Re: 1376 Campus Road  
Final Subdivision and Land Development Plan – Phase 3  
Township Permit No. 25-05-FLDP  
LCEC Project No: 25-100

PROJECT TITLE  
1376 CAMPUS ROAD - PHASE 3  
FINAL SUBDIVISION &  
LAND DEVELOPMENT PLAN  
MOUNT JOY TOWNSHIP  
LANCASTER COUNTY, PA

Re: Final Subdivision & Land Development Plan for 1376 Campus Road – Phase 3  
Our File No. 10221-1

PROJECT TITLE: 1376 CAMPUS ROAD - PHASE 3  
FINAL SUBDIVISION & LAND DEVELOPMENT PLAN  
SHEET TITLE: MOUNT JOY TOWNSHIP LANCASTER COUNTY, PA  
STORMWATER DETAILS

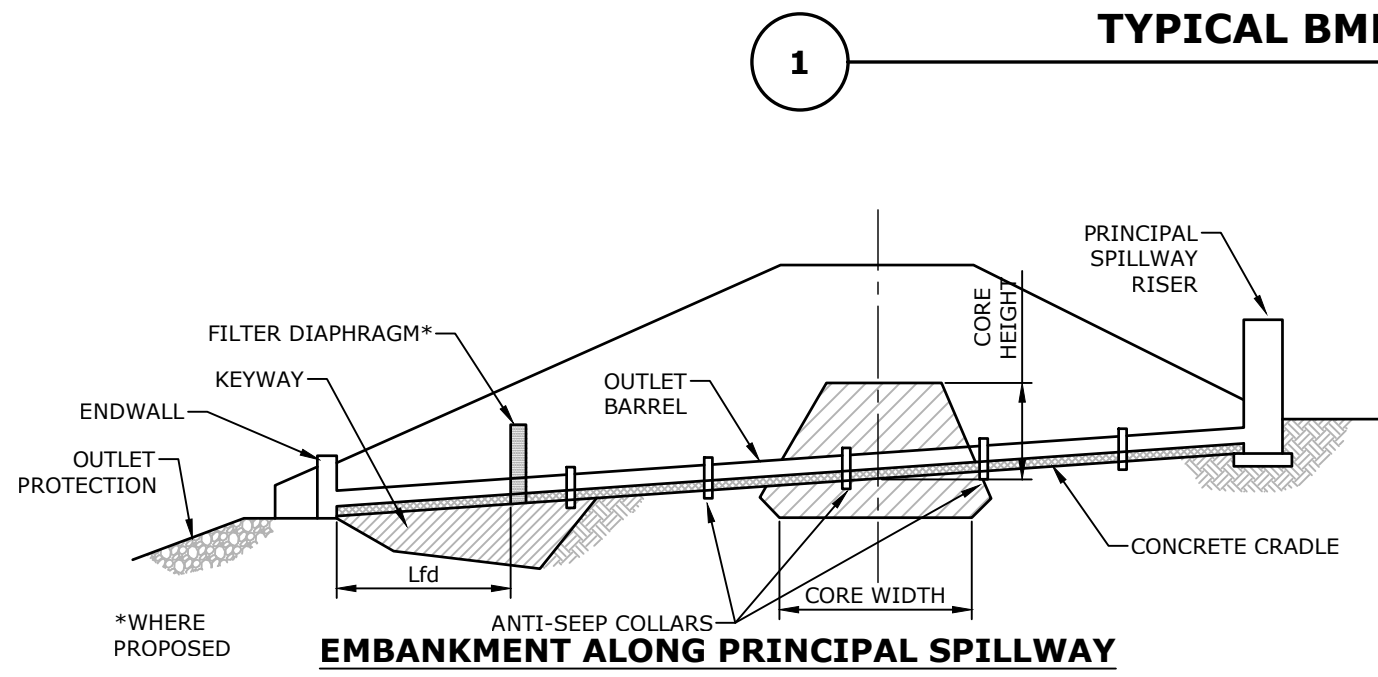
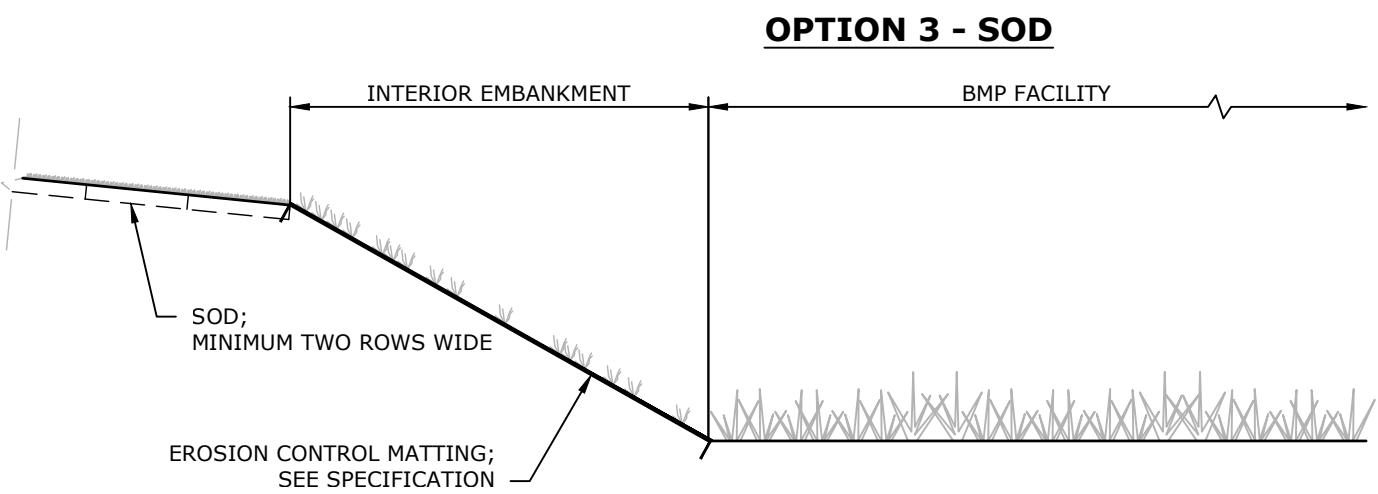
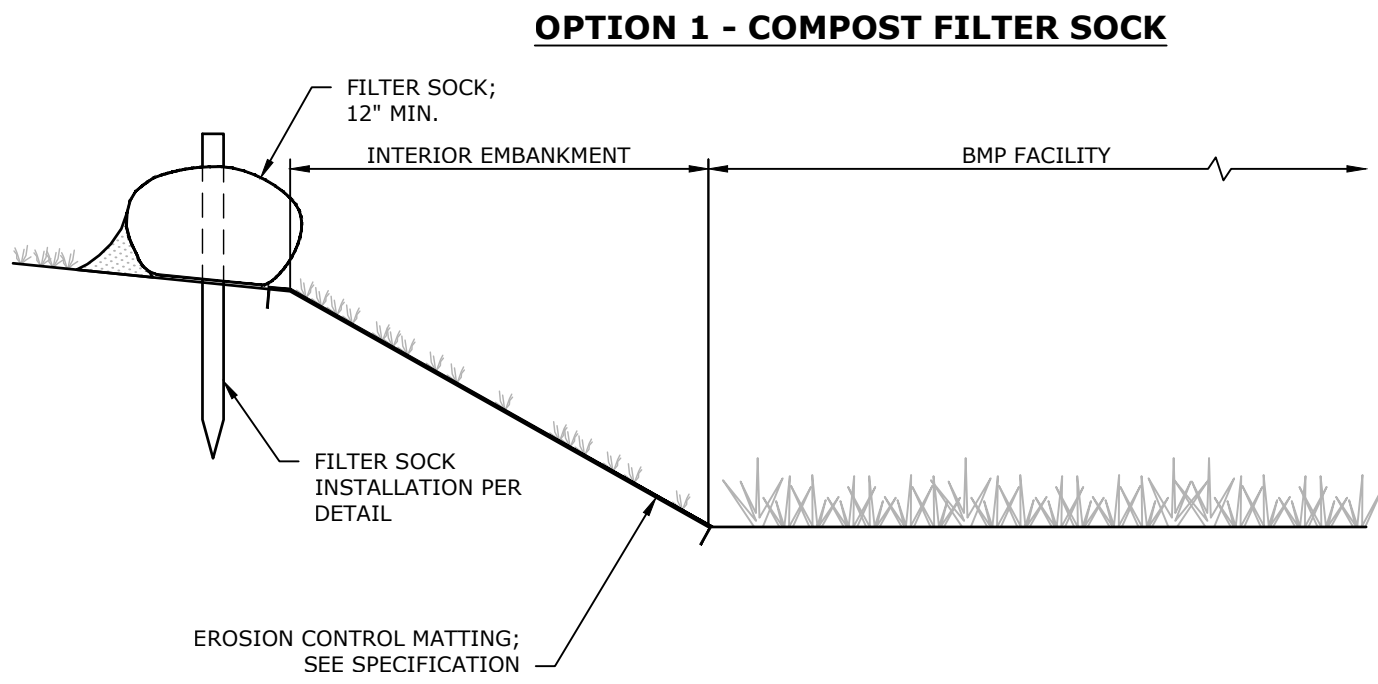
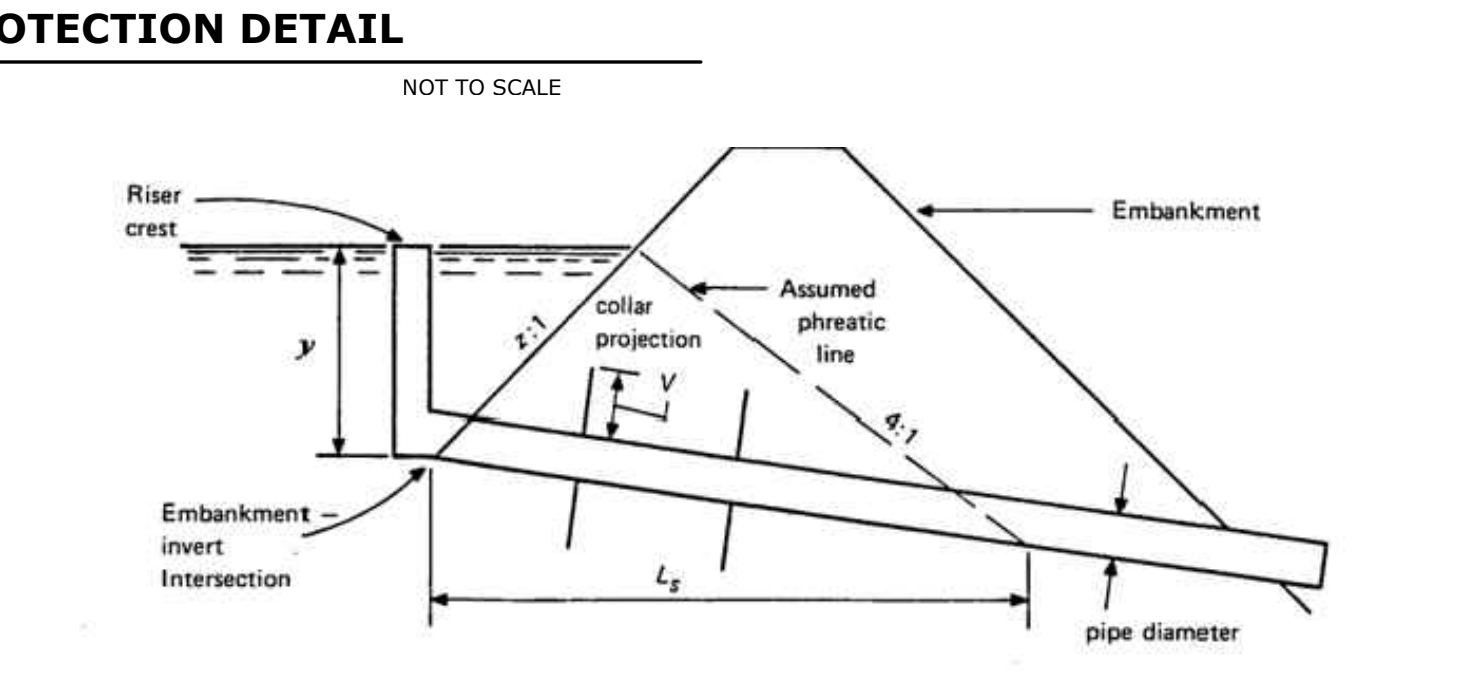
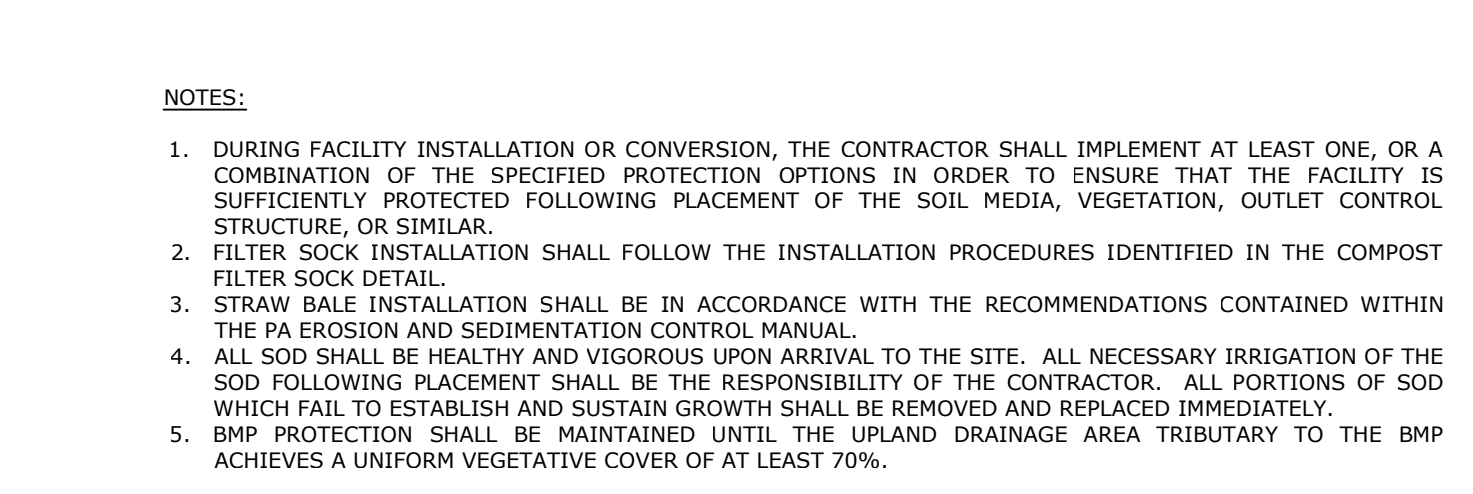
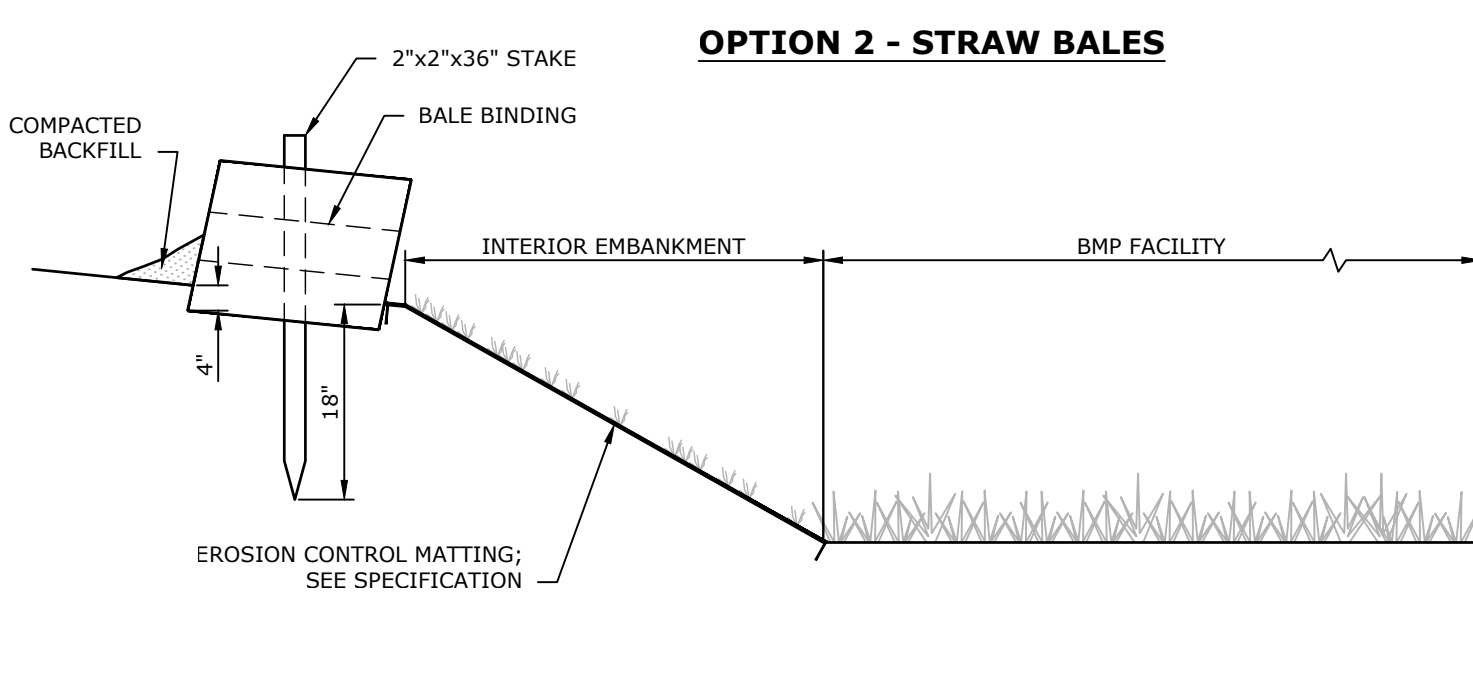
Add Swale 20
